## CITY OF ALBUQUERQU

7050 Barstow St NE Re:

**Traffic Circulation Layout**

Based upon the information provided in your submittal received 01-18-18, the above referenced plan cannot be approved for Building Permit until the following comments are addressed:

Architectural Site Plan

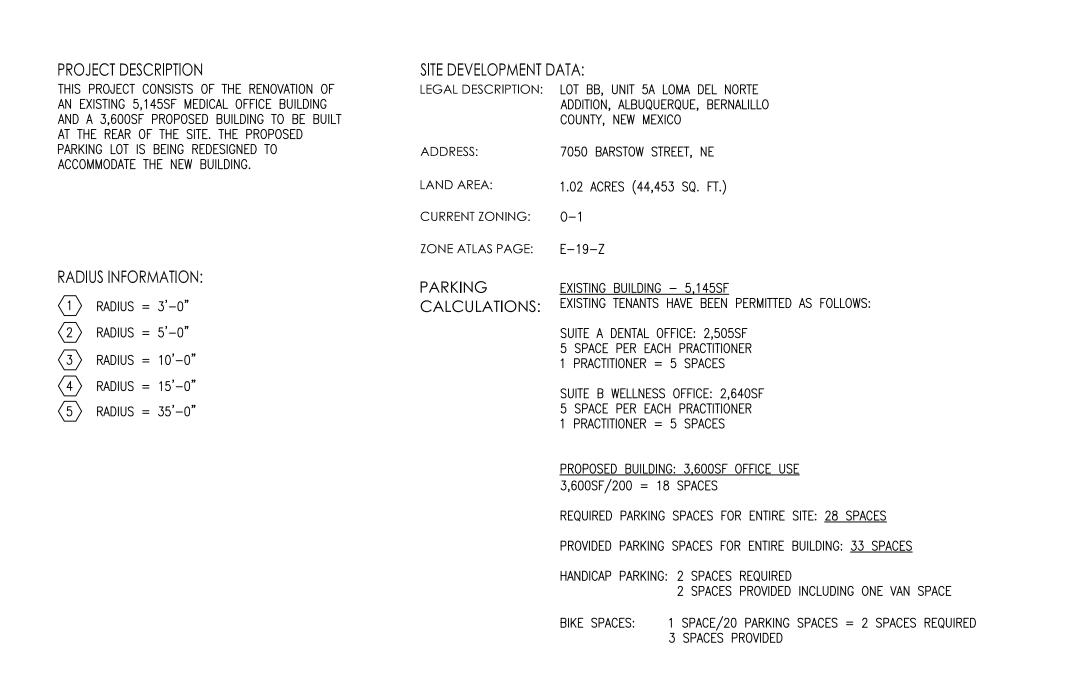
- Identify the right of way width, medians, curb cuts, and street widths on 1. Barstow.
- Two way travel lanes must be a minimum of 24 feet. 2.
- The ADA accessible parking sign must have the required language per 66-7-3. 352.4C NMSA 1978 "Violators Are Subject to a Fine and/or Towing." Please call out detail and location of HC signs. All ADA parking spaces must be updated to current standards.

- The ADA access aisles shall have the words "NO PARKING" in capital letters, 4. each of which shall be at least one foot high and at least two inches wide, placed at the rear of the parking space so as to be close to where an adjacent vehicle's rear tire would be placed. (66-1-4.1.B NMSA 1978)

- Per the zoning code, a 6 ft. wide ADA accessible pedestrian pathway is 5. required from the public sidewalk to the building entrances. Please clearly show this pathway and provide details.

- Unused curb cuts must be replaced with sidewalk and curb & gutter. A build note must be provided referring to the appropriate City Standard drawing. Please specify the City Standard Drawing Number when applicable.

ADA ramps cannot extend into the ADA access aisle. 7.
